Item Name: Fwd Crosstube - Mid Height 206L / L1 / L3 / L4, Blue

DART AEROSPACE LTD		Work Order: 162185
Description: Crosstube Mid Fwd (206L)		Part Number: D206-667-107
Inspection Dwg: D206-667-147	Rev: A	Page 1 of 1

DRAWING NO. D206-667-147	TITLE CROSSTUBE ASS'Y (206L MID FWD)	REV. A	DART AEROSPACE LTD ENGINEERING ORDER		D.E.O. NO. D206-667-147-A-1	SHEET NO. SHEET 1 OF 1	SCALE NTS
DRAWN 90	CHECKED 455		MFG. APPR. [Signature]	APPROVED [Signature]		DE APPR. [Signature]	
DATE 11.07.15	DATE 11.07.20		DATE 11.07.21	DATE 11.07.21		DATE 11.07.21

DRAWING NO. D206-667-147		TITLE CROSSTUBE ASS'Y (206L MID FWD)		REV. A	DART AEROSPACE LTD ENGINEERING ORDER		D.E.O. NO. D206-667-147-A-2	SHEET NO. SHEET 1 OF 1	SCALE NTS
DRAWN AJS		CHECKED		MFG. APPR. <i>E</i>		APPROVED <i>AP</i>		DE APPR. <i>AP</i>	
DATE 12.08.02		DATE 12.08.02		DATE 12.08.02		DATE 12.08.02		DATE 12.08.02

DETAIL P
 BONDING STRAP INSTALLATION 2 PL

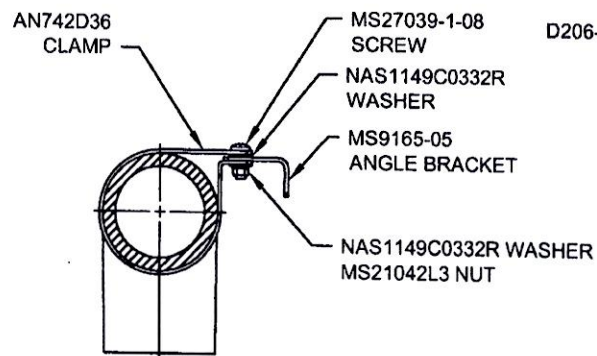
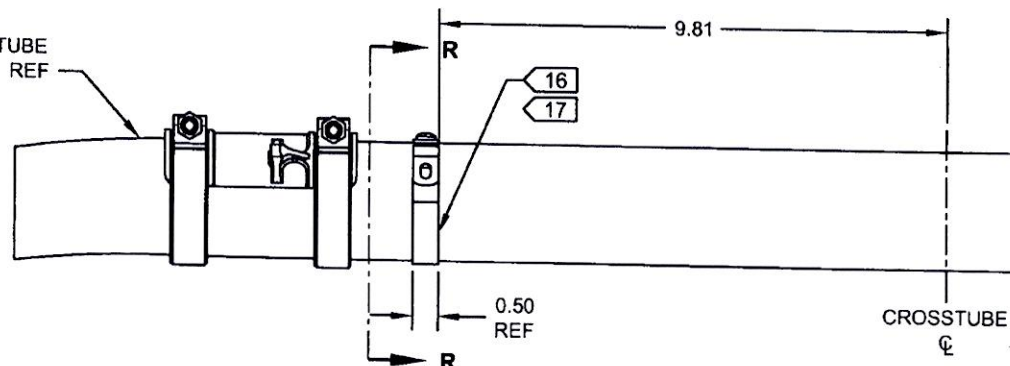
PURPOSE:

ADD ELECTRICAL GROUNDING STRAP

ITEM	QTY -147	PART NUMBER	DESCRIPTION
1	X	D206-667-147	CROSSTUBE ASSEMBLY (206L MID FWD)
10	2	AN742D36	CLAMP
11	2	MS9165-05	ANGLE BRACKET
12	2	MS21042L3	NUT (OR MS21042-3)
13	2	MS27039-1-08	SCREW
14	4	NAS1149C0332R	WASHER (OR AN960C10L)

- 16) MASK AREA UNDER CLAMP PRIOR TO PAINTING
 17) SEAL EDGES WHERE AN742D36 CLAMP MEETS WITH THE CROSSTUBE USING SIKAFLEX-241/-291 OR MIL-S-8802 CLASS B2 OR PROSEAL 890 SEALANT
 18) PERFORM RESISTANCE CHECK TO ENSURE MAX RESISTANCE IS 10 MILLIOHMS
